PLANNING AMENDMENTS

TWICKENHAM STADIUM EAST STAND EXTENSION

LEVEL 3 PLAN - SOUTH

100-KSS-DR

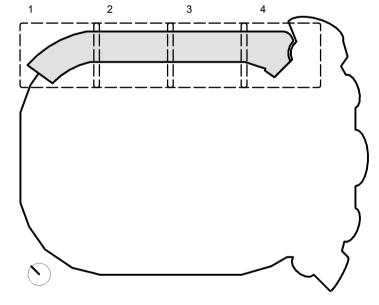
- GENERAL AMENDMENTS TO THE SOUTH END.
 INCREASED SHINGLES CLADDING AREA AND CURTAIN
 WALL REDUCED ACCORDINGLY.
 REDUCED MASSING AND REVISED INTERFACE WITH
 THE SOUTH STAND.

- PPC LOUVRES LOCATED TO THE BOWL SIDE HAVE
- BEEN OMITTED. CURTAIN WALL SETTING OUT REVISED GENERALLY.
- SILICONE JOINTS TO TRANSOMS AND MULLION REPLACED WITH CAPPED SYSTEM. LEVEL 04 PPC LOUVRES SETTING OUT & HEIGHT REVISED. MONORAIL

- FOR ABSEILING REMOVED. GENERAL AMENDMENTS TO THE CENTRAL ELEVATION
 CANOPY AT LEVEL 5A REVISED GENERALLY AND
 STANDING SEAM REPLACED WITH SINGLE PLY
 MEMBRANE. SUPPORT COLUMNS TO ROOF CANOPY

- REVISED. SQUARE FASCIA TO ROOF EDGE. LEVEL 5A GLAZED SCREEN EXTENDED IN HEIGHT AND PPC LOUVRES INCLUDED AT LOW LEVEL.
- INCREASED SHINGLES CLADDING AREA AND CURTAIN WALL AREA REDUCED ACCORDINGLY. FOUR VERTICAL FINS REMOVED.

- PORCELAIN PANELS WITH SLOTTED HOLES FOR VENTILATION REPLACED WITH PPC LOUVRES. EXPRESSED HORIZONTAL PATTERN TO PORCELAIN PANELS OMITTED.
- GENERAL AMENDMENTS TO THE NORTH END PORCELAIN CLADDING REPLACED WITH PPC

- ALUMINIUM CLADDING. GREEN WALL TO THE NORTH END EXTENDED AND PPC
- LOUVRES REMOVED. INCREASED SHINGLES CLADDING AREA AND CURTAIN
- WALL REDUCED ACCORDINGLY.
 FENCELINE, GATE AND PERIMETER COLUMNS SETTING
 OUT REVISED.
 CANOPY TO TURNISTILES REVISED.
 PORCELAIN PATTERN CHANGED FROM HORIZONTAL TO
 VERTICAL.

- PORCELAIN PANELS TO THE SOFFIT OF THE ARCH
- REPLACED WITH PPC ALLUMINIUM PANELS. PORCELAIN PANELS SETTING OUT REVISED. ROOF TO LEVEL 5A (NORTH END) EXTENDED.

- GLAZED SPANDREL PANELS REPLACED WITH METAL
- SPANDREL PANEL. PORCELAIN PANELS REPLACED WITH PPC ALUMINIUM CLADDING. PPC LOUVRES INCLUDED FOR MECHANICAL VENTILATION.
